120 INCH (POSSIBLE) DOME SHUTTER CABLE MODIFICATION

SERVICE QUOTATION

Quotation No. MB102008

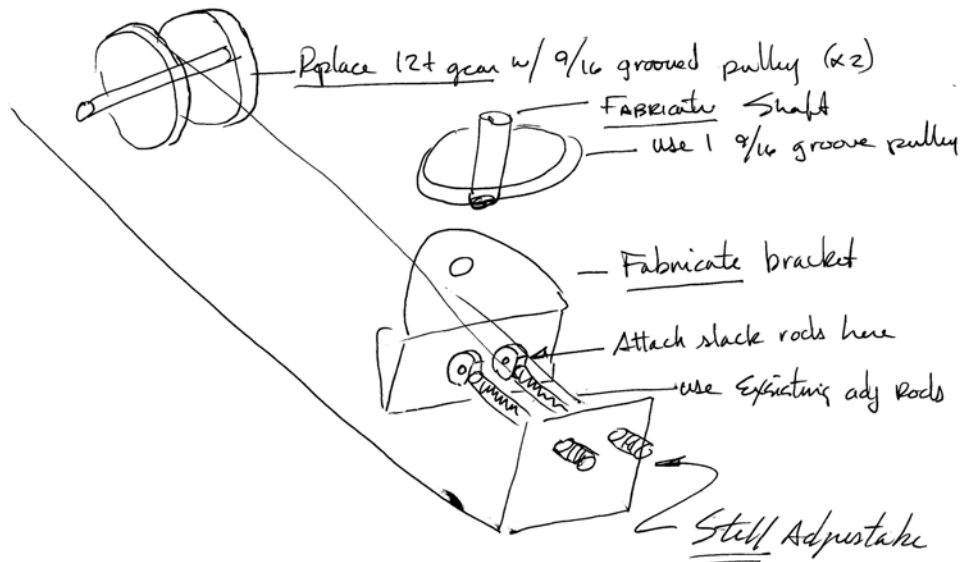
MIKE:

LICK-

- 1) ENGINEERING (DNR) Requires 3 Rope clips
- 2) CROSSY Requires 3 Rope Clips
- 3) SYSTEM Requires LOAD SHARING ON ALL CABLES
- 4) Repair 1 side would require the other side to be Adjusted - to be able to load share all four cables
- 5) if clips pull again - (if installed "to get by") what then?
- 6) with out proper load share; Shutter could Drop @ any time. Very Dangerous! who would own liability
- 7) suggestion below Low \$ impact, easy to install/fabricate, easy to adjust! Would be only 1 rope and NO Clips!

A will all before entry to Crane @ lockheed

Suggested: 1 rope per side w/adjustment

120 INCH (POSSIBLE) DOME SHUTTER CABLE MODIFICATION

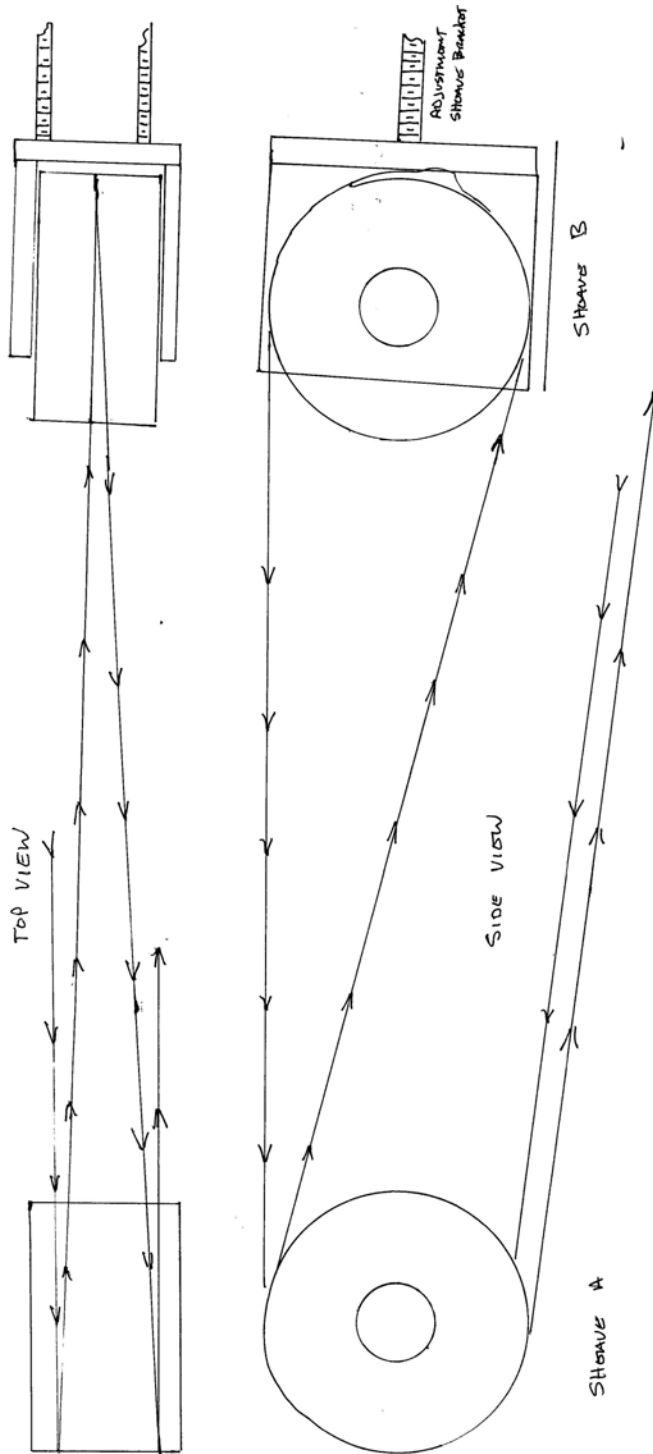
ONE WIRE ROPE TO UTILIZE BOTH UP & DOWN
 WILL REQUIRE 1 ROPE UP & DOWN ATTACHED
 TO HOIST DRUMS NO ROPE CLIP REQUIRED
 AT SHUTTER ADJUSTMENT POINT
